UNITED STATES
NUCLEAR REGULATORY COMMISSION
WASHINGTON, D.C. 20555-0001

SUBJECT: COLUMBIA GENERATING STATION - STAFF ASSESSMENT OF INFORMATION PROVIDED UNDER TITLE 10 OF THE *CODE OF FEDERAL REGULATIONS* PART 50, SECTION 50.54(f), SEISMIC HAZARD REEVALUATIONS FOR RECOMMENDATION 2.1 OF THE NEAR-TERM TASK FORCE REVIEW OF INSIGHTS FROM THE FUKUSHIMA DAI-ICHI ACCIDENT (CAC NO. MF5274)

STAFF ASSESSMENT BY THE OFFICE OF NUCLEAR REACTOR REGULATION

COLUMBIA GENERATING STATION

Figure 3.4-4. Licensee's sensitivity analysis of GMRS to minimum spectral amplification values, copied from Figure 4 in Swank (2015b).

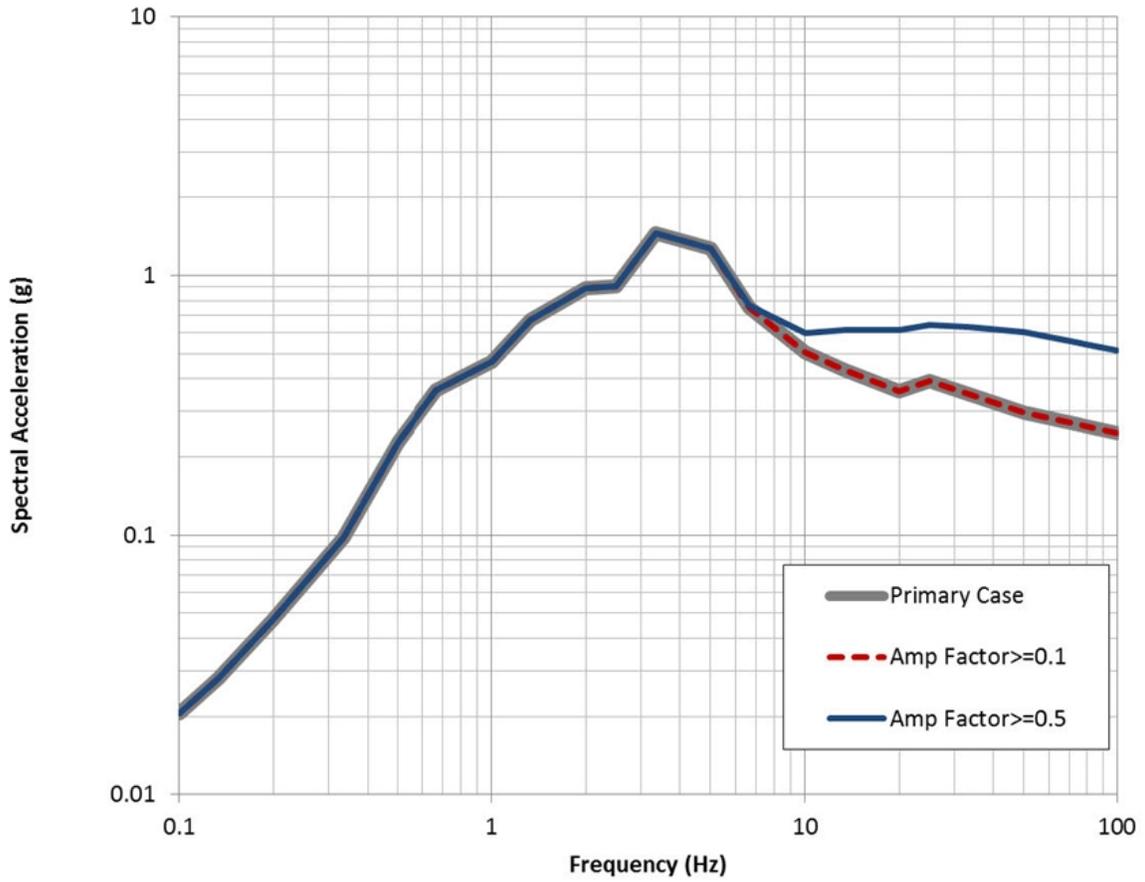
In an RAI to the licensee, the NRC staff asked the licensee to justify its decision to not implement the minimum amplification factor of 0.5, as recommended in the SPID (EPRI, 2012). In its response (Swank, 2015b), the licensee stated that amplification factors less than 0.5 have been reported by other analysts using both equivalent linear and nonlinear methods. To demonstrate the impact of not using a minimum value of 0.5, the licensee performed a sensitivity analysis with minimum amplification factors set to 0.1 and 0.5. As shown in Figure 3.4-4 of this staff assessment, the results of the licensee's analysis showed that the GMRS in the frequency range of 1 Hz to 10 Hz is insensitive to the minimum amplification factor but that the higher frequencies are moderately impacted. Based on its confirmatory site response analyses, the NRC staff concludes that the combination of (1) the impedance contrast between the interbed and basalt layers; and (2) the material damping of the interbeds, results in the low amplification factors for the higher spectral frequencies. Because these two factors are actual physical characteristics of the Saddle Mountain Basalts, the staff concludes that limiting the site amplification factors to a minimum value of 0.5 is not necessary for this site. Therefore, the NRC staff concludes that the licensee's decision to not use the minimum value of 0.5 is appropriate for the CGS site.
